RE: Lot 16 Block 1 Volcano Cliffs Unit 22 SAD 228 8011 Agua Fria NW Grading and Drainage Plan Engineers Stamp Date 10/29/2020 (D10D003N16)

Based upon the information provided in your submittal received 11/2/2020, this plan is approved for Grading Permit.

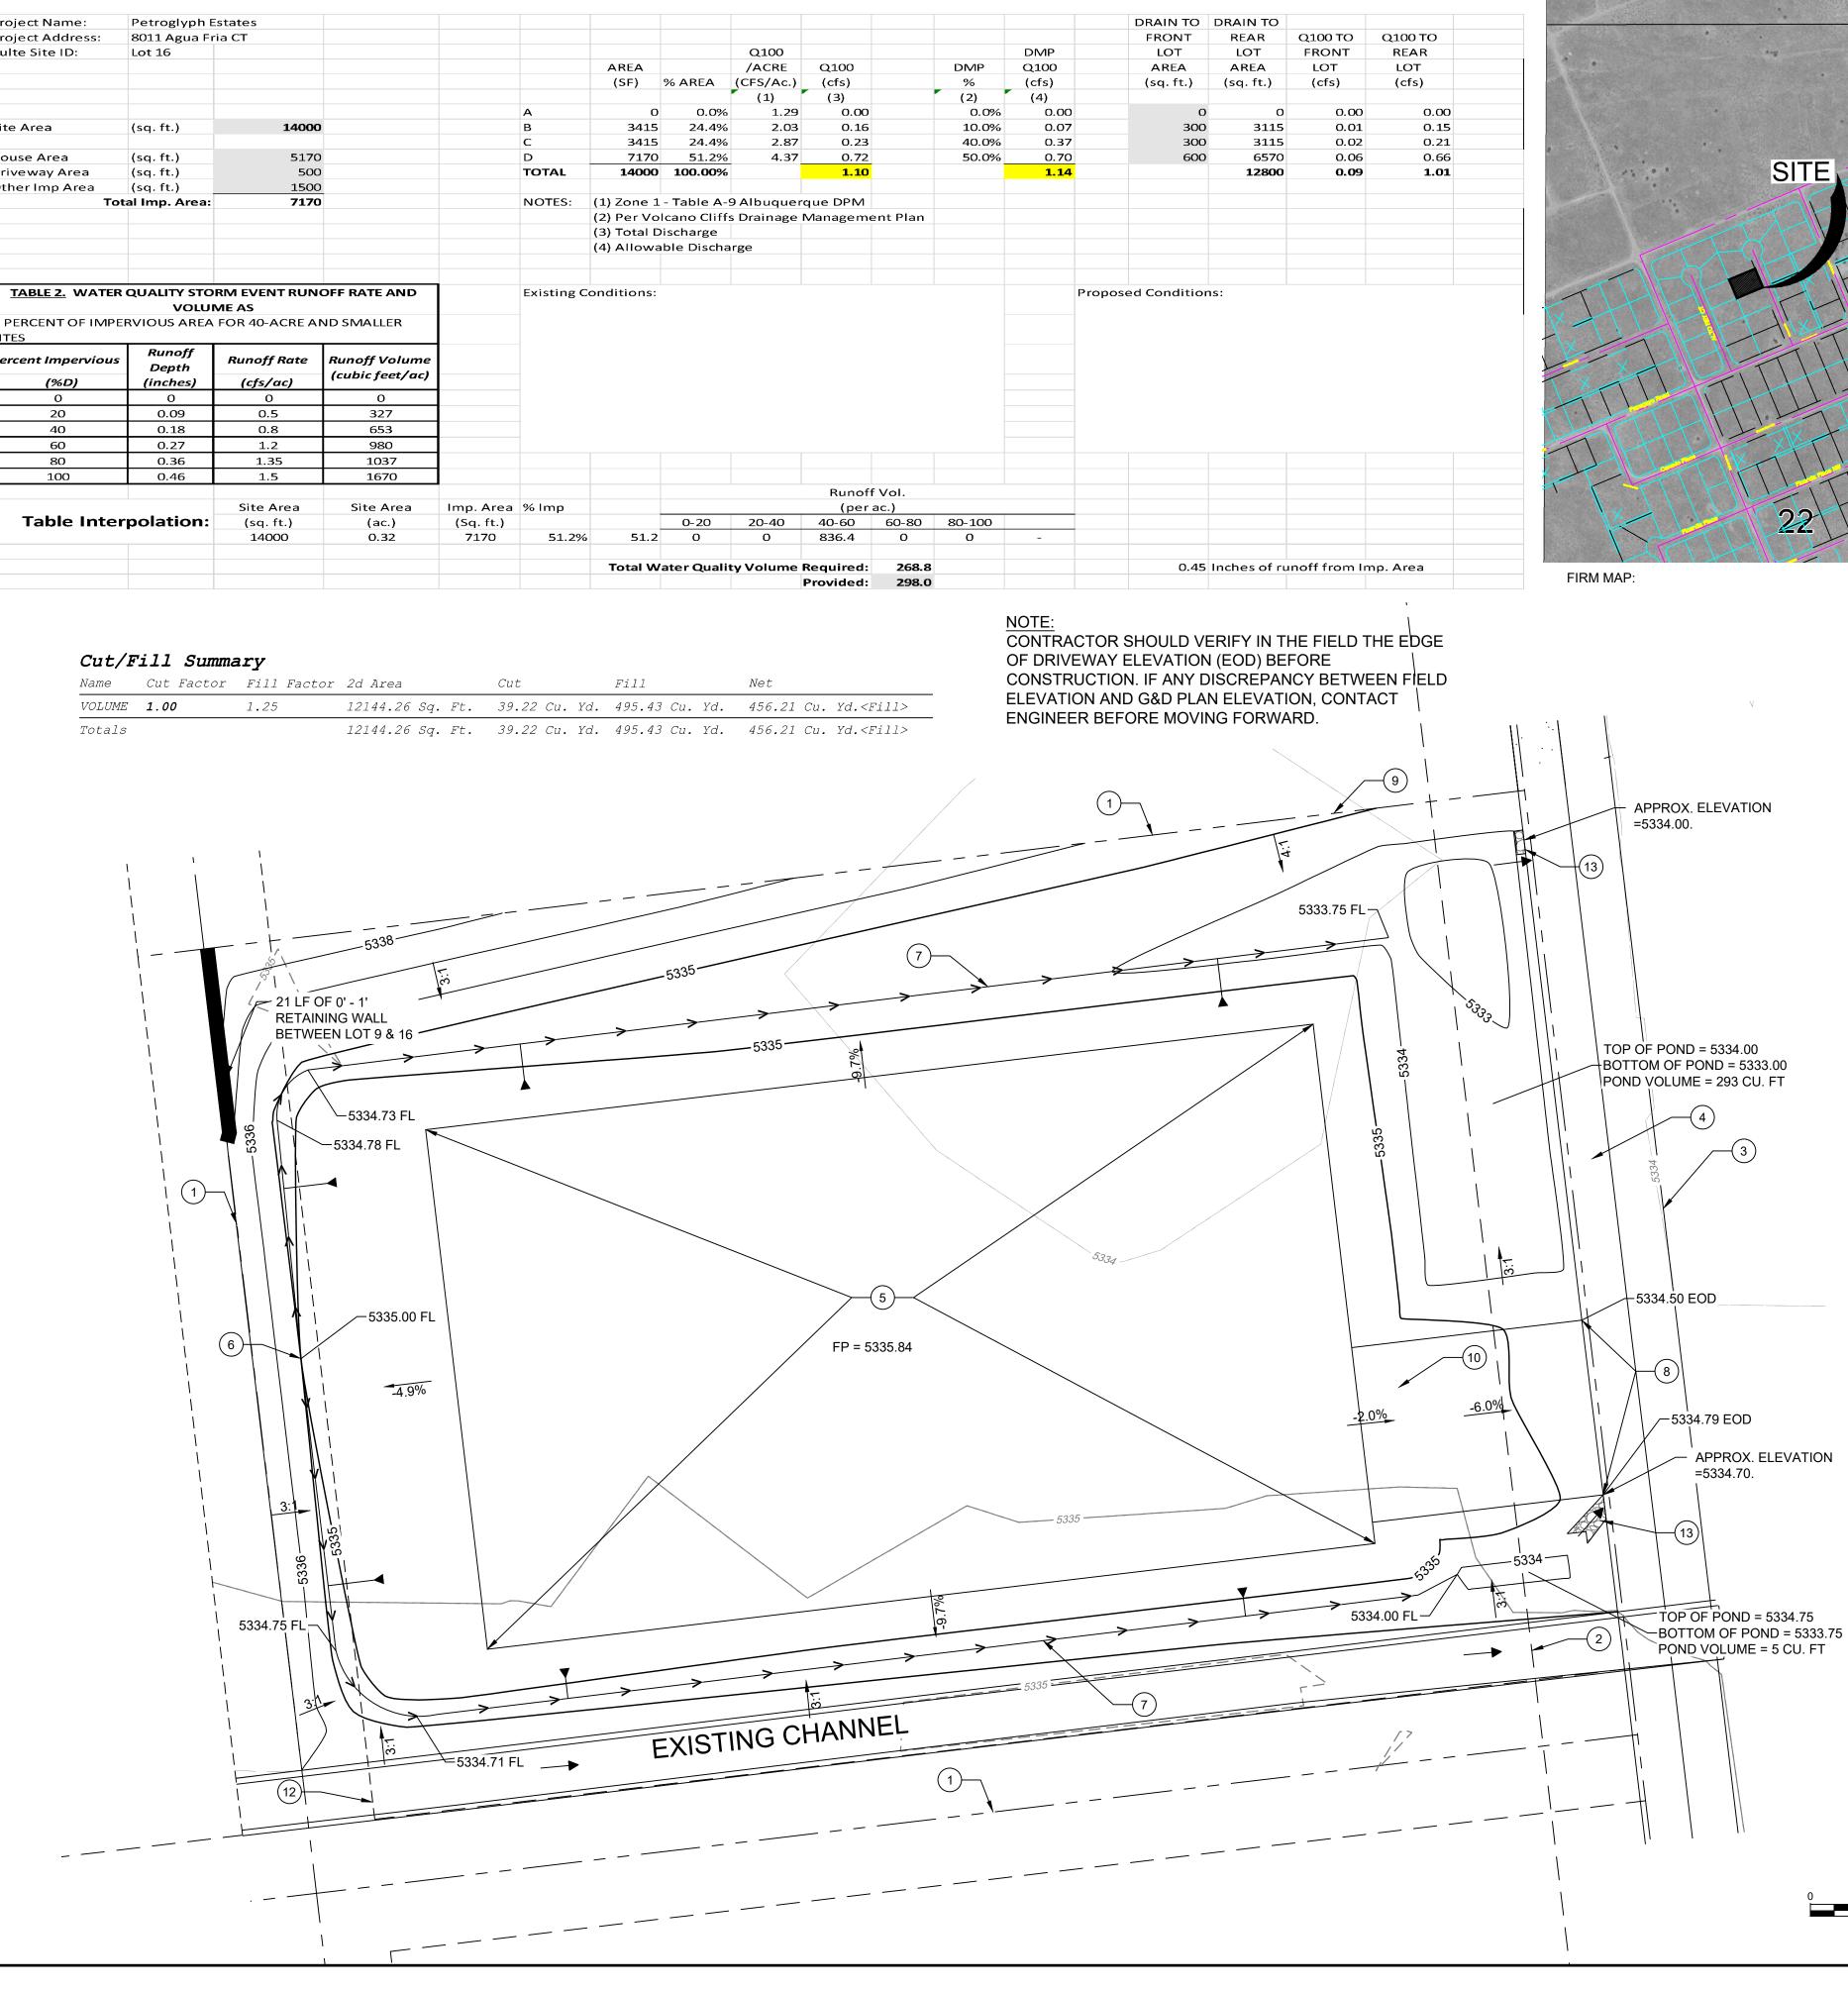
Prior to Building permit approval a Pad Certification will be required, provided by the Engineer or a registered Land Surveyor.

Reiterate to the Owner/Contractor that a separate permit for a garden/retaining wall must be obtained with the approved G&D plan and Pad Certification. Also, if a swimming pool is to be placed the grading and drainage plan will change and will need to be resubmitted.

www.cabq.gov Prior to Certificate of Occupancy release, Engineer Certification per the DPM checklist will be required.
